TRANSMITTAL OF MEETING HANDOUT MATERIALS FOR IMMEDIATE PLACEMENT IN THE PUBLIC DOMAIN

Docket Number(s)	N/A
Plant/Facility Name	N/A
TAC Number(s) (if available)	N/A
Reference Meeting Notice	
Purpose of Meeting (copy from meeting notice)	Public meeting to discuss comments by the Nuclear Energy Institute regarding the International Nuclear Event Scale

SUBJECT: NEI International Nuclear Event Scale Recommendations May 2003

International Nuclear Event Scale (INES) Meeting

PWR Typical Technical Specification Activity Example Curve

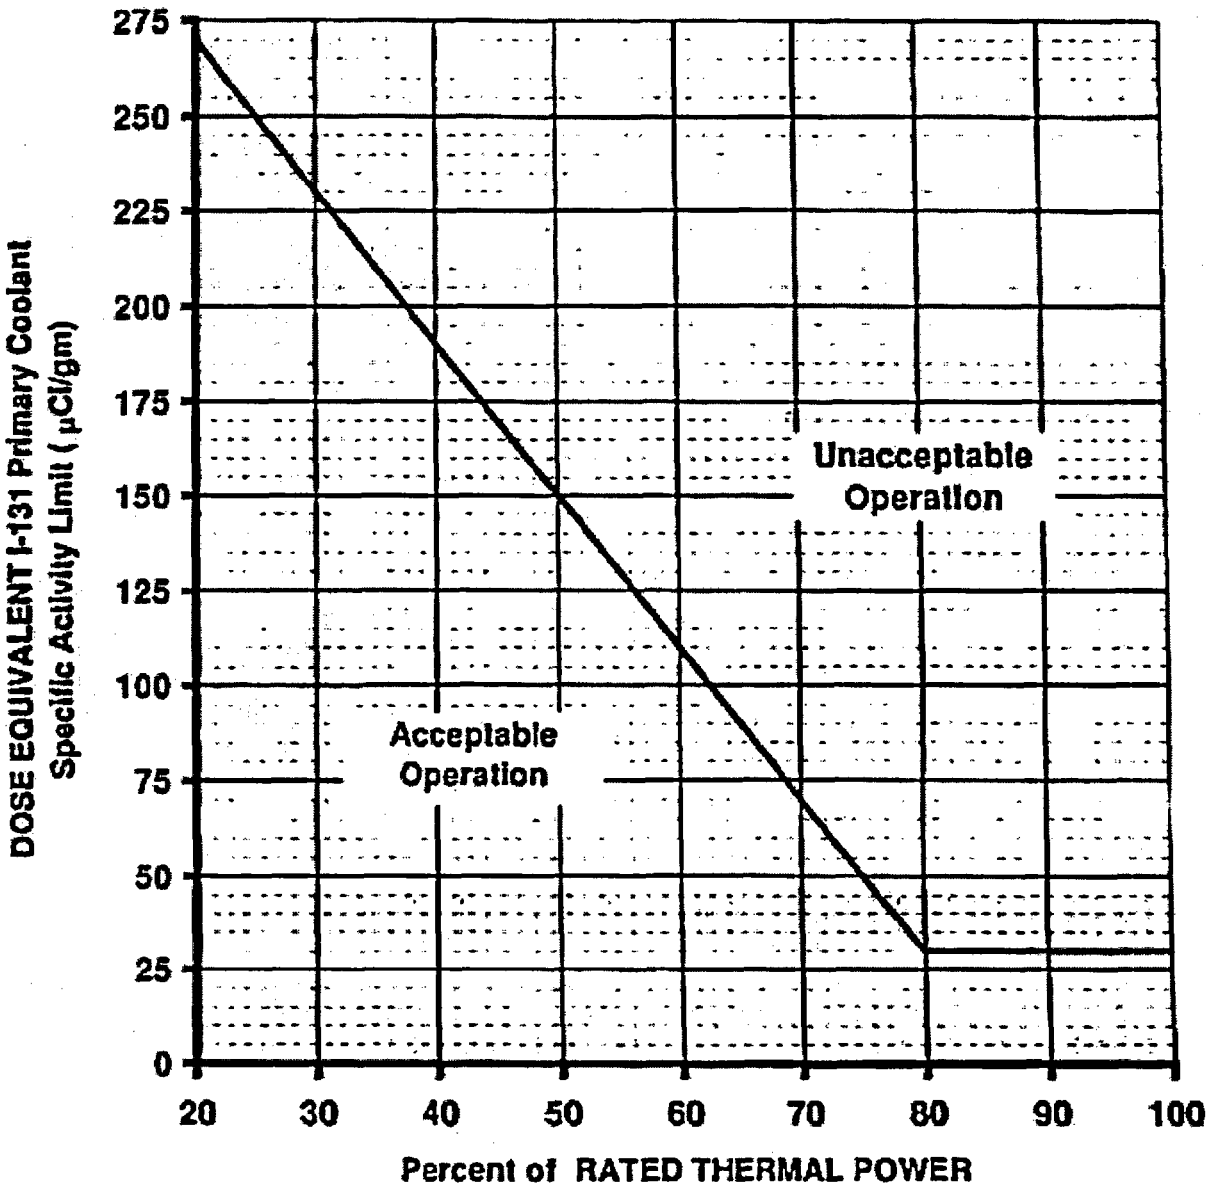
DEI elevated into the Unacceptable Operation region of the Technical Specification transient limit requiring shutdown.

DEI elevated into the Allowable Operation region of the Technical Specification transient limit for greater than the specified action statement time limit requiring shutdown.

DEI elevated out of normal Technical Specification operating limit but returned to within normal operating limit within specified action statement time limit with no shutdown required

Example is consistent with current Defense-In Depth approach. If Level 2 criteria is met then the event is most likely not due to just an Iodine spike therefore indicating potential clad failure. Level 2 classification is therefore appropriate. This definition is consistent with the Emergency Action Level (EAL) classification methodology of NEI 99-01, Revision 4, for a Notification of Unusual Event based on a Technical Specification required shutdown. Escalation to level 3 would occur should reactor coolant activity exceed 300 μc/cc DEI.

Example is consistent with current Defense-In Depth approach. If Level 1 criteria is met then the event is most likely due to an Iodine spike and not an indication of potential clad failure. Level 1 classification is therefore appropriate. This example would probably not result in the Emergency Action Level (EAL) classification methodology of NEI 99-01, Revision 4, being exceeded since the plant would most likely be shutdown proactively prior to exceeding the action statement time limit. Technical Specifications would require notifications and documentation of the event per the LER process. Escalation to level 2 would occur should reactor coolant activity exceed the Allowable Operation region of the transient limit curve.

Example is consistent with current Defense-In Depth approach. If Level 0 criteria is met then the plant is operating within normal licensed parameters and no safety risk exists. Level 0 classification is therefore appropriate. This example would not result in the Emergency Action Level (EAL) classification methodology of NEI 99-01, Revision 4, being exceeded and would therefore not result in an emergency classification. Escalation to level 1 would occur should reactor coolant activity increase above normal operating limits and not return within the allowable transient time limit.

PWR Technical Specification Example

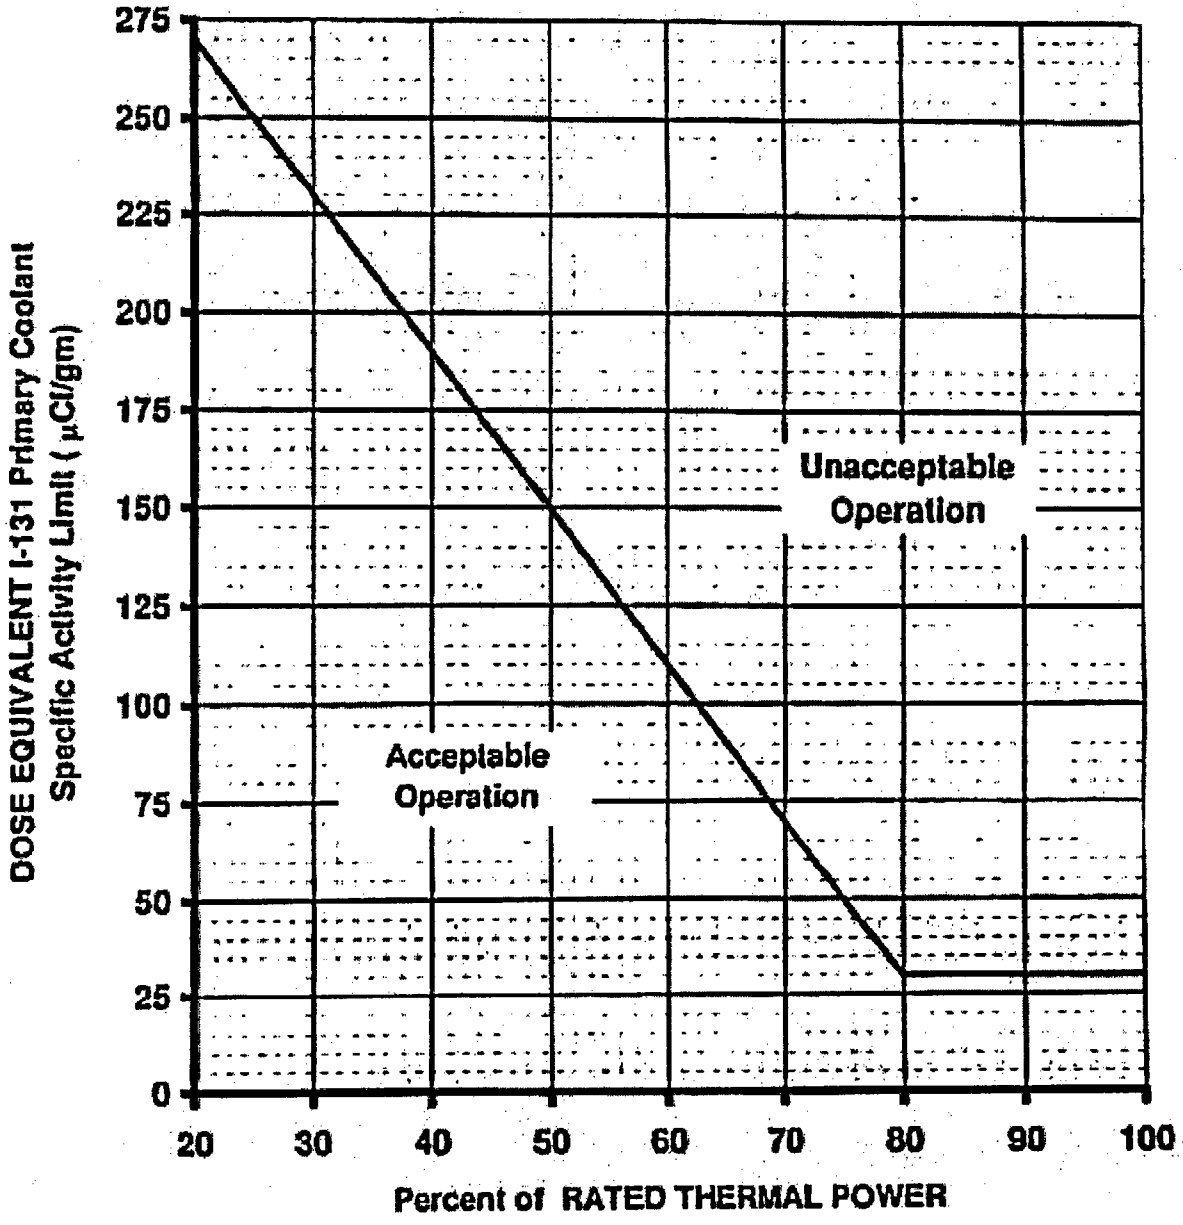
- Level 2
  - DEI elevated into the Unacceptable Operation region of the Technical Specification transient limit requiring shutdown
- Level 1
  - DEI elevated into the Allowable Operation region of the Technical Specification transient limit for greater than the specified action statement time limit requiring shutdown
- Level 0
  - DEI elevated out of normal Technical Specification operating limit but returned to within normal operating limit within specified action statement time limit with no shutdown required
